CITY OF SAN ANTONIO

Re: New Prue Road

MDP # 022-06

NEW PRUE ROAD MDP

NEW PRUE ROAD MDP
 MASTER DEVELOPMENT PLAN

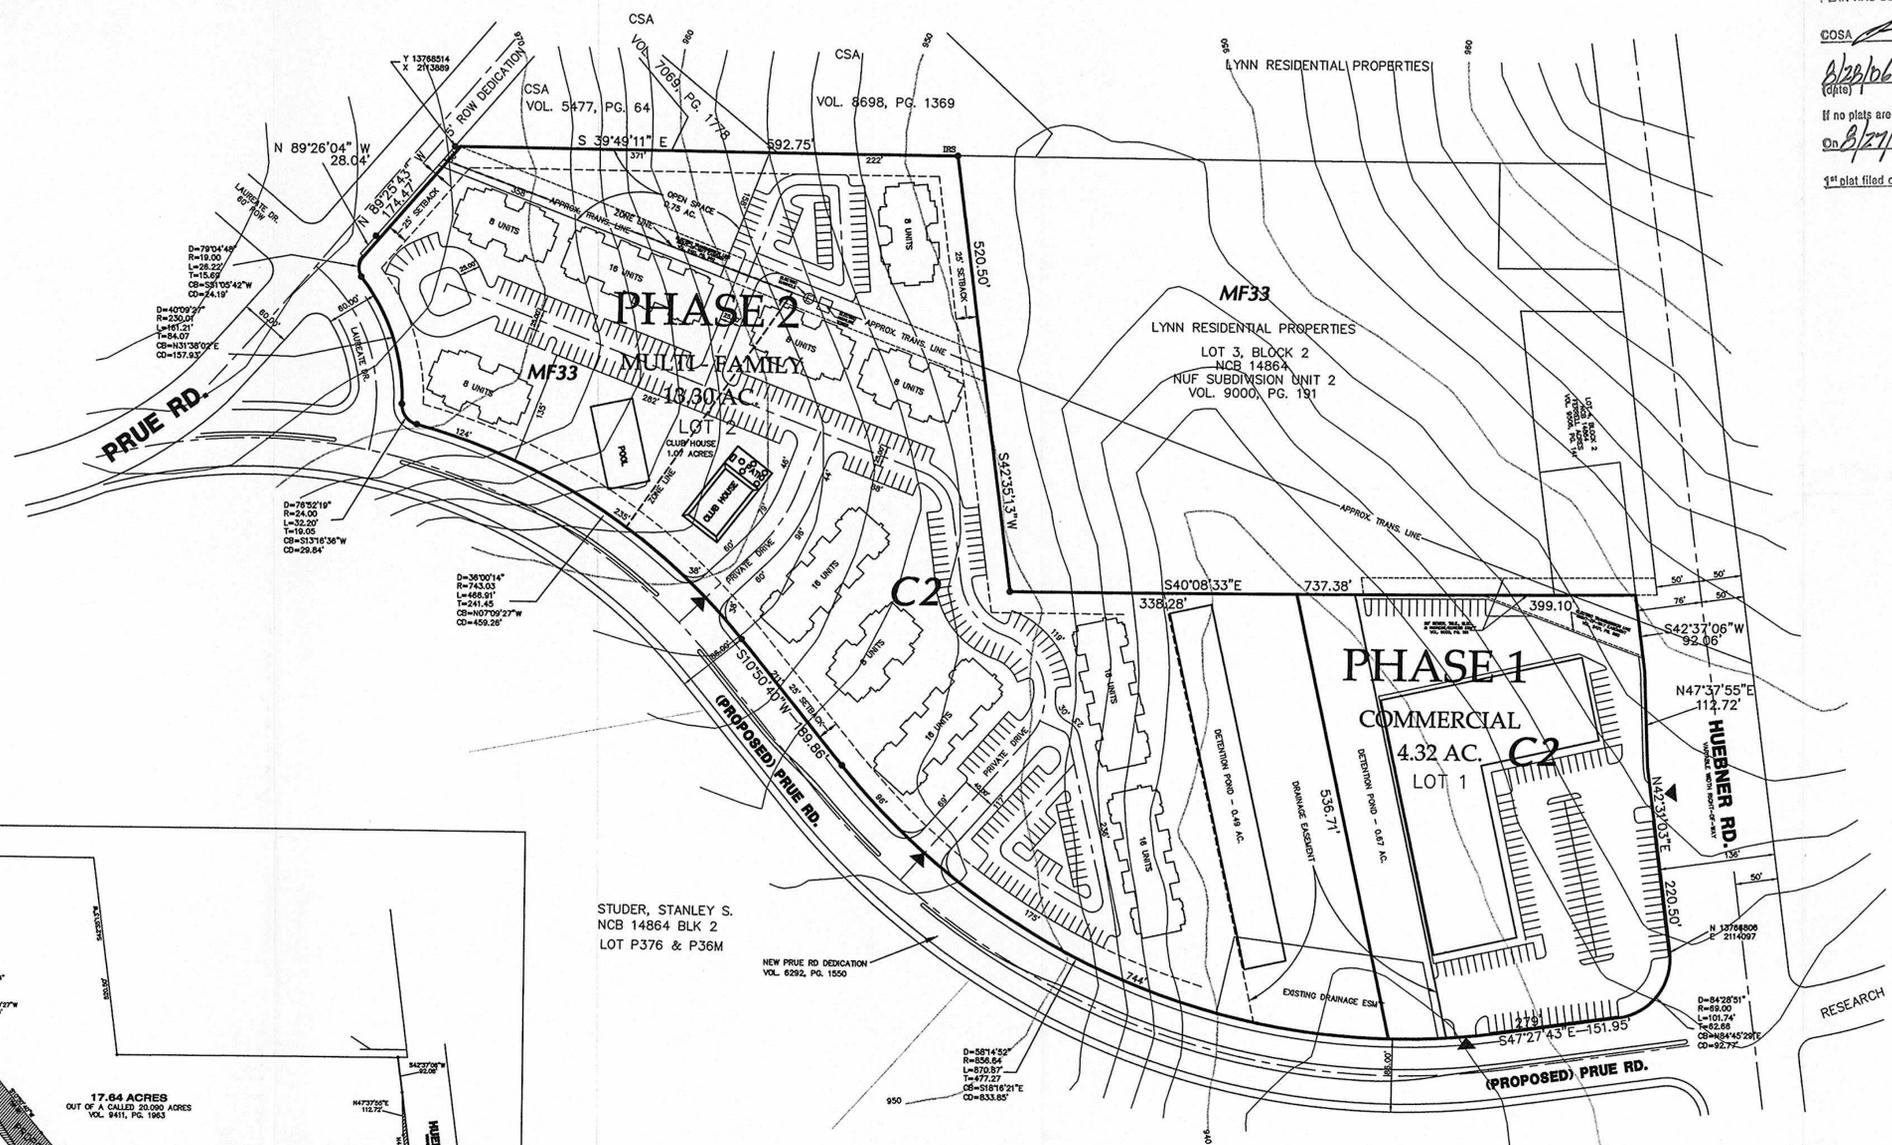
- In consideration of public safety and convenience, excessive grades by reason of topography should be avoided in street layouts and arrangements.
- Any access and R.O.W. issues along state facilities will need to be resolved with the **Texas Department of Transportation (TXDOT)**. For information about these requirements you can contact TXDOT at 615-5814.

- **Parks** recommends approval with the following conditions:
 - The parkland provided is dedicated to the owners of the proposed multi-family units.
 - The note stating the Home Owner's Association responsibilities be removed if there will be no HOA for this proposed development.

- **Trees** approves with the following conditions:
 - 2003 Tree Preservation ordinance standards per UDC 35-523 – a Master Tree Permit has been approved for this development – A/P 1052162.

- Streetscape standards apply as per UDC Section 35-512 (we recommend preservation of existing trees where available and possible)
- It will be expected that you will plat all of the property depicted in your Master Development Plan (M.D.P.) to include floodplains, drainage areas and open space.
